Meeting Agenda

Zoning Board of Appeals
Wednesday, October 09, 2024
5:30 PM

- 2. ZBA 2024-009: Design Review** for Approval of a **5,616 SF Storage Building** located at **5313 Ross Lane** (PIN: 04-28-377-006).
[Property Owner: Forest City Gear Co. (Fearless Fred LLC)]
- 3. ZBA 2024-010: Design Review** for Approval of a **160 SF Accessory Storage Structure** located at **4767 Bluestem Road** (PIN: 04-29-428-004).
[Property Owner: Tony Pipitone (Little Mariano Inc.)]
- 4. ZBA 2024-011: Public Hearing for a Variance** request to waive the requirement for installation of a **fence surrounding ground-mounted solar panels** located at **11380 Main Street** (PIN: 04-33-127-002).
[Property Owner: Michael Miller]

OVERALL SITE
PLAN

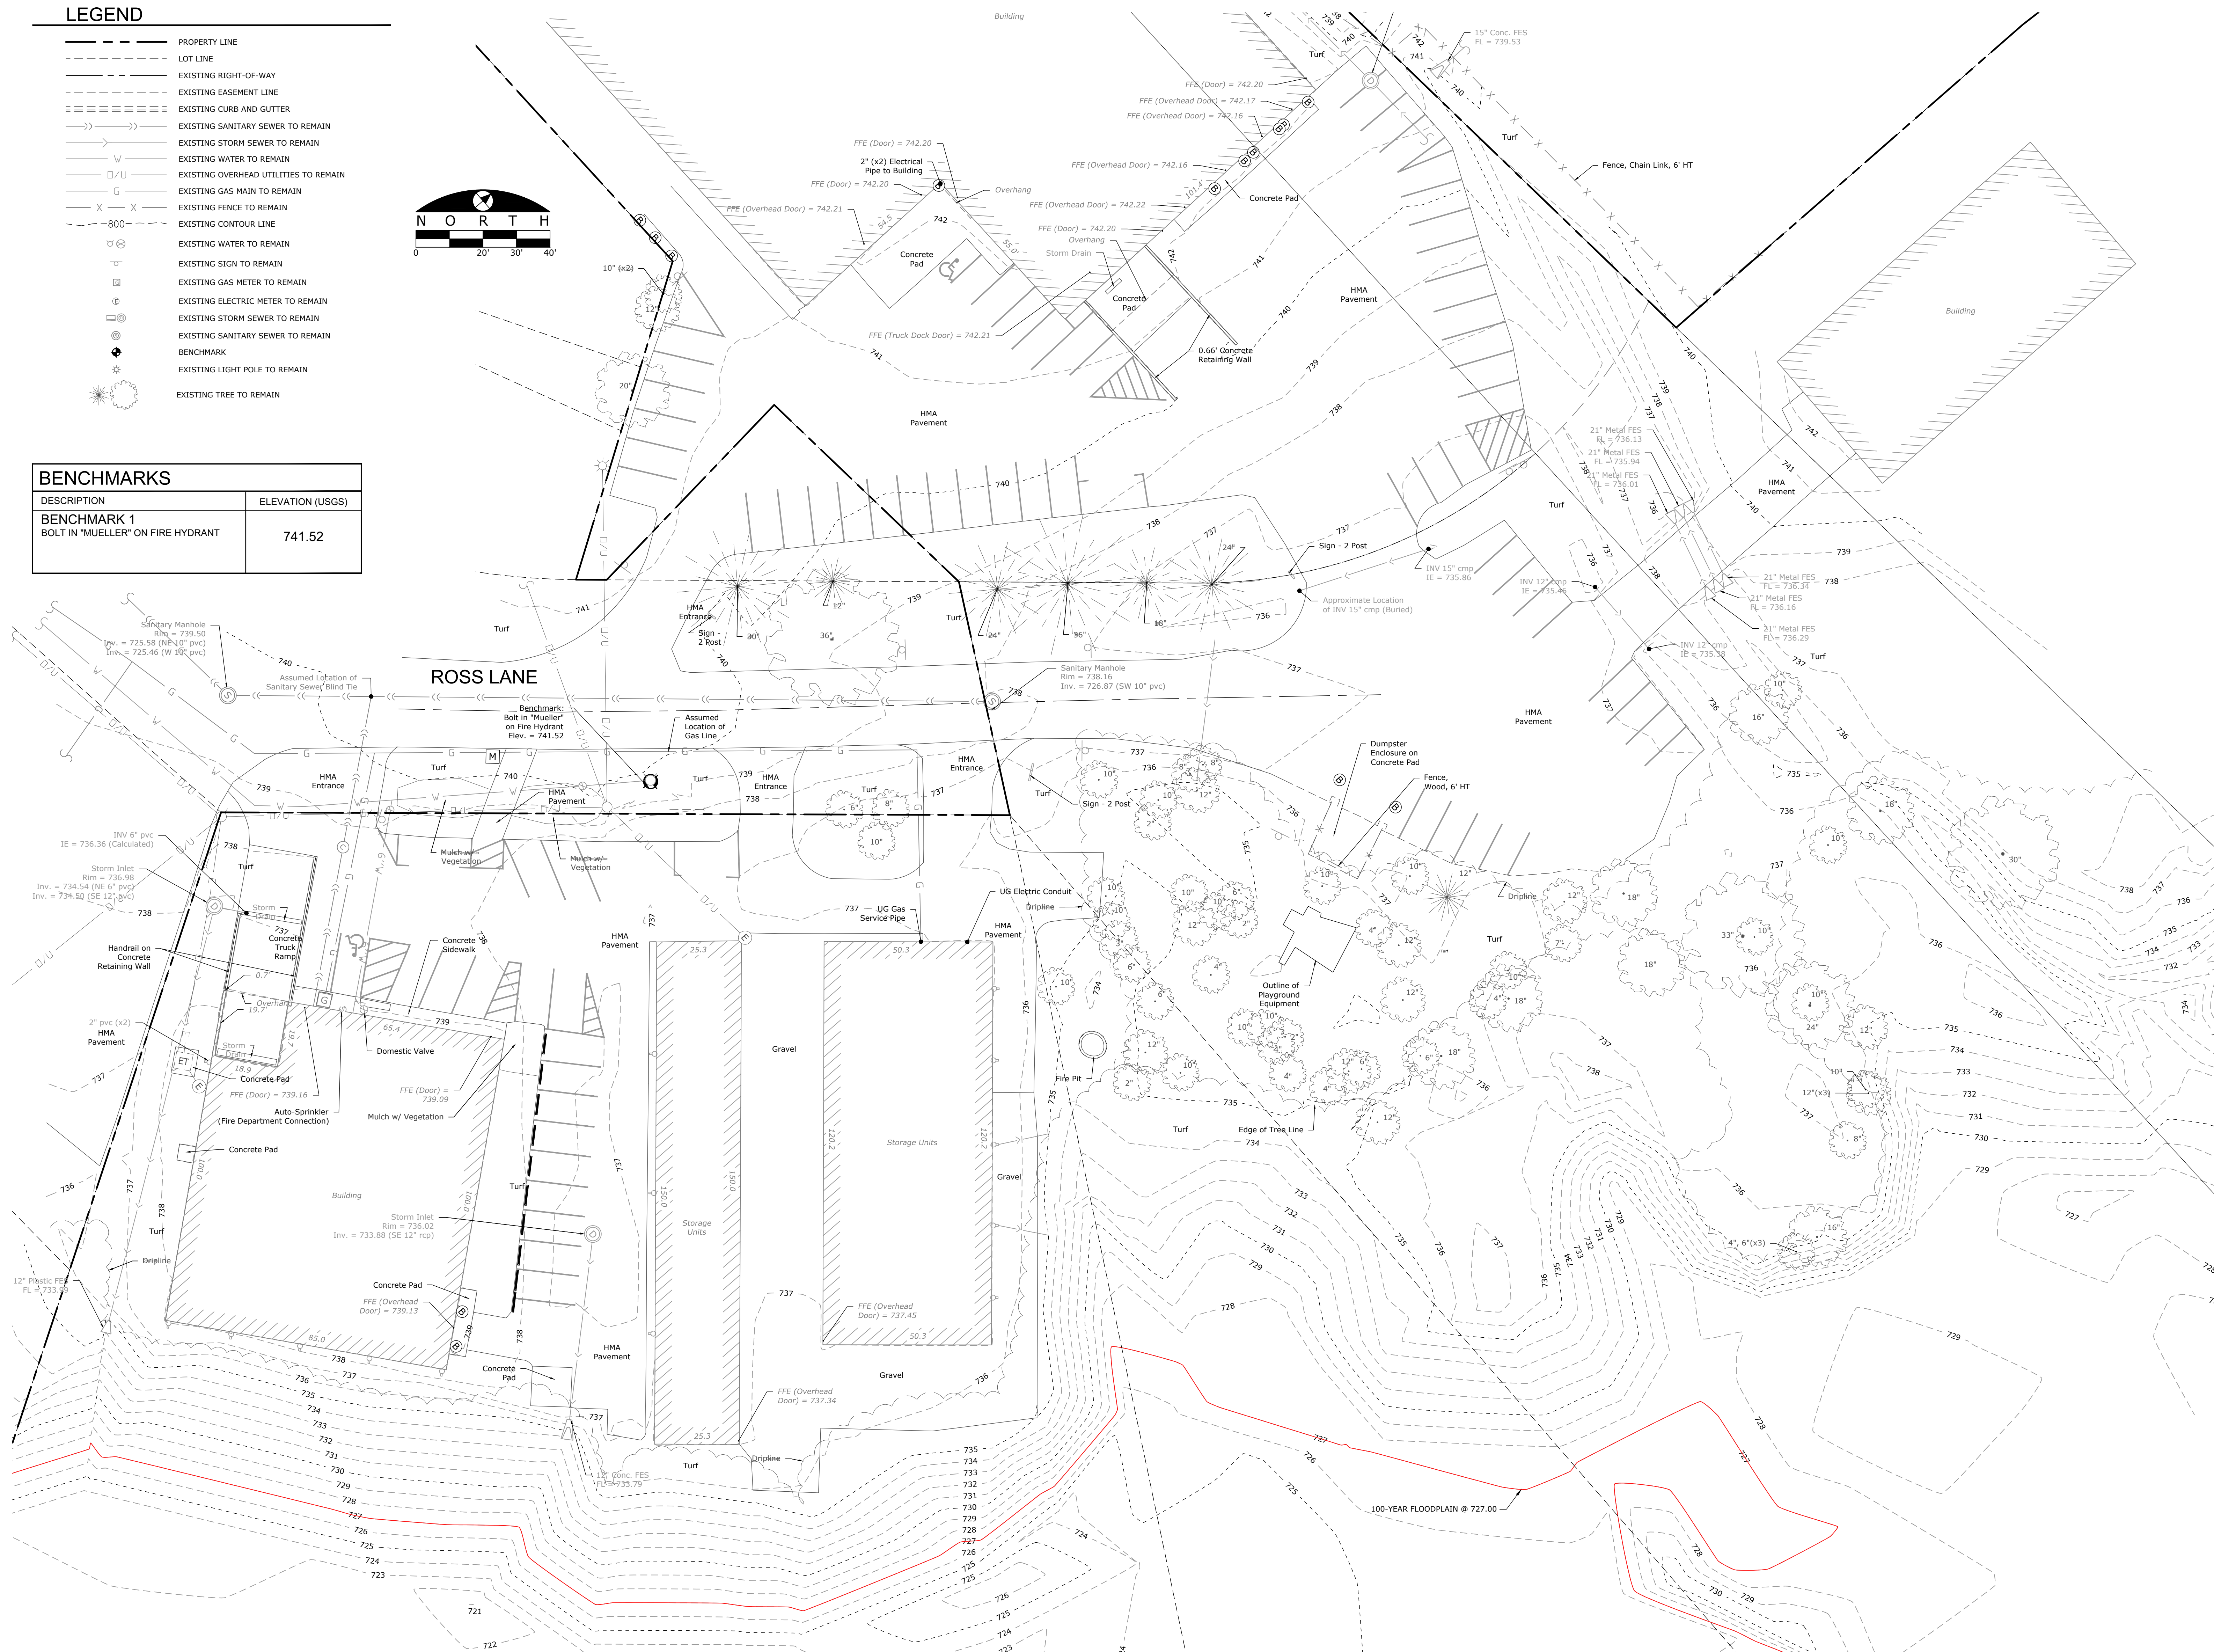
1. Increase side setback from 10.9 feet to at least 18 feet (10% of lot width at frontage).
We had a conversation with the Village Administrator and our client earlier this week. Originally, a 10' setback was agreed to at a meeting with Village staff. The Village stated that was under the understanding that the main plant lots and this lot were intended to be combined, making this building an accessory structure. Our client still intends to combine the three parcels into one, but the timing of this project is in advance of that action. The Administrator has agreed to allow the 10' setback with the understanding that the parcel combination is forthcoming. Therefore we have not shifted the building. We left our conversation with the agreement that the 10' setback will be approved.

2. Landscaping for the site. Required around:
 - Foundation base of building
Added along the side of building facing the end of the public street. The other three sides face the internal property and remaining tree line.

- Screening of dumpster area/mechanical equipment.
Added along with a partial fence
3. If possible, move parking area from front of building to one side or the other.
For the functionality of the site, we are not able to do this. Parking remains as submitted.

Overhead Doors

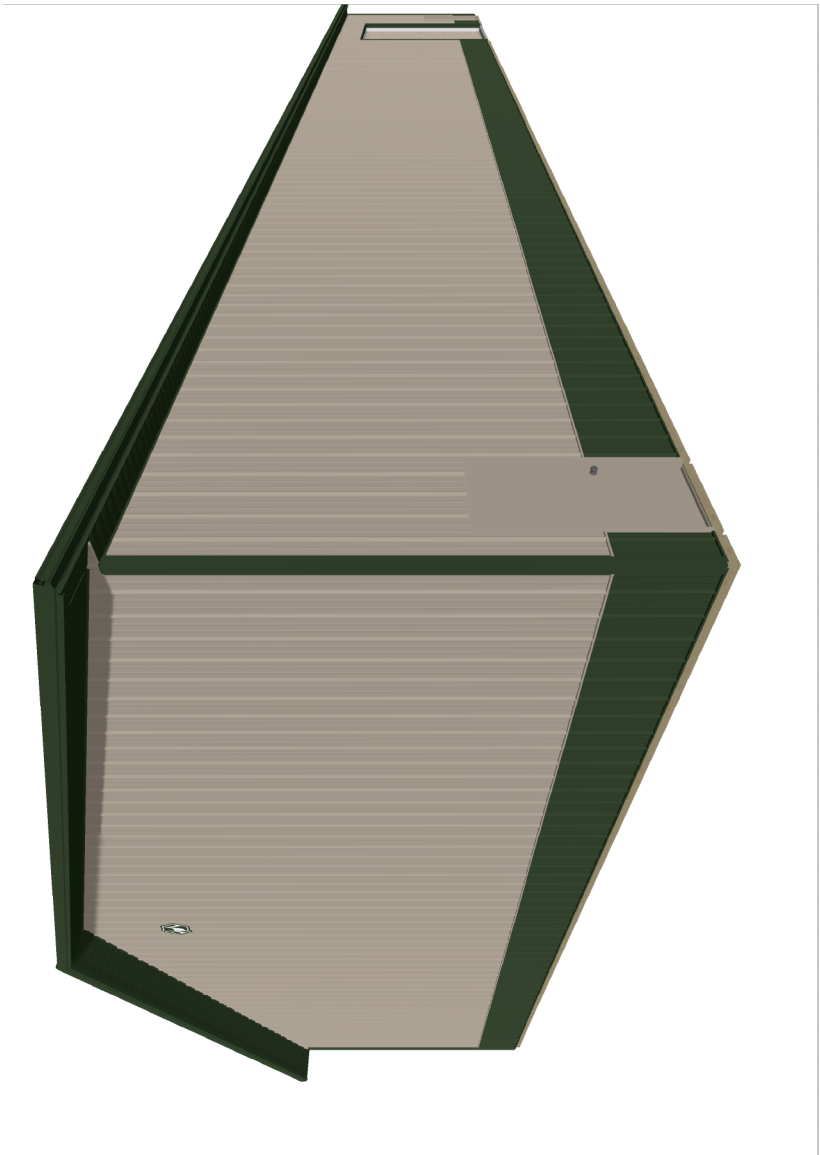
Moved "D" (12'0" x 14'0" Overhead Door Opening (Requires a minimum 12' 2" X 14' 1" panel), OHD/Operator requires 1' 8" Headroom, Available Headroom is 2' 1") from 90' 2.25" on the North wall to "C" 90' 2.25" on the North
